Dolby Laboratories Inc

Field Bulletin 207

Model CP45 Improvements to the Cat. No. 511 Main Board

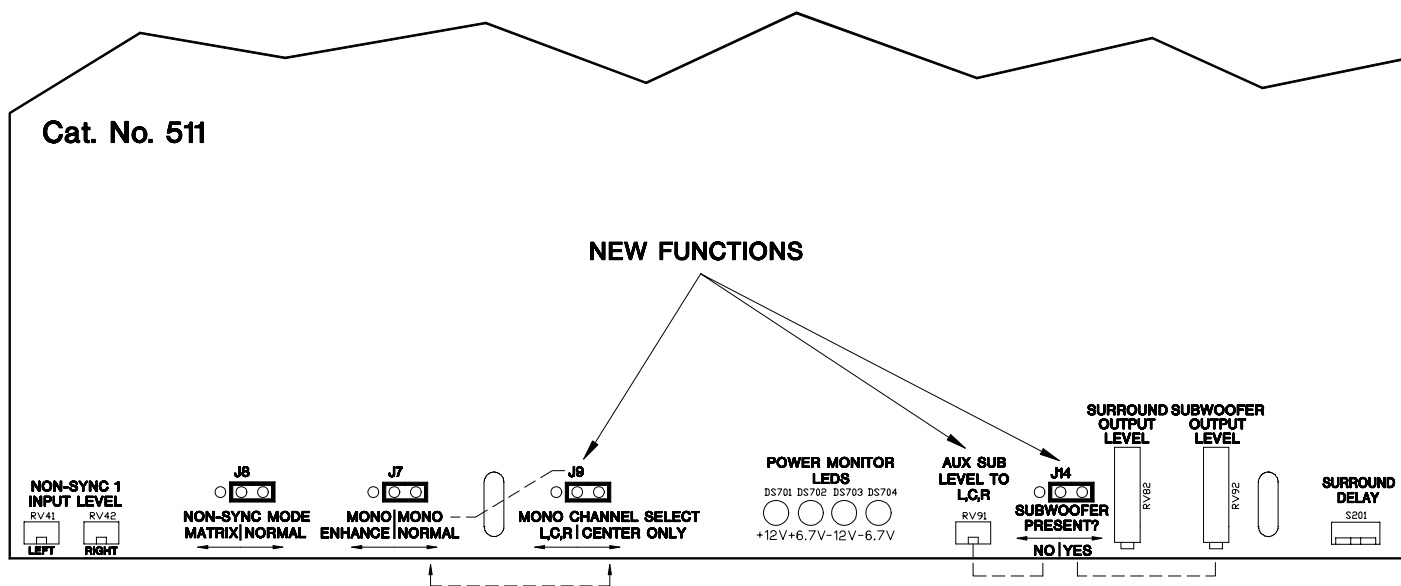
Mono Channel Selection - New Jumper J9

To the right of the left hand plastic pillar supporting the Cat. No. 511 is a new jumper, J9. The jumper provides a choice of sending Mono film sound (Format 01) to the center channel only or to the left, center and right channels. The factory default setting is "CENTER ONLY".

If it is required that Mono sound should be heard through Left, Center and Right loudspeakers then move Jumper J9 to the left position, "L , C , R".

Original Jumper J7 located to the left of the new J9 must be in the "MONO NORMAL" position. Jumper J9 operates when jumper J7 is in this position only.

Subwoofer Signal from Aux Input - New Jumper J14 and Level Control RV91

To the right of the power indicator LED's is a new jumper and level control. The jumper provides a discrete path from the **Aux SW** input to the subwoofer output.

For theatres equipped with a subwoofer, the jumper should be set to "SW PRESENT". In this case the new level control (**RV91**) **has no effect** and the existing subwoofer level control (RV92) is used as described in the installation manual.

If the theatre has no subwoofer loudspeaker installed, the jumper should be set to "NO SW" . In this case the new level control (RV91) adjusts the level of the **Aux SW** signal which is sent to the three front channels.
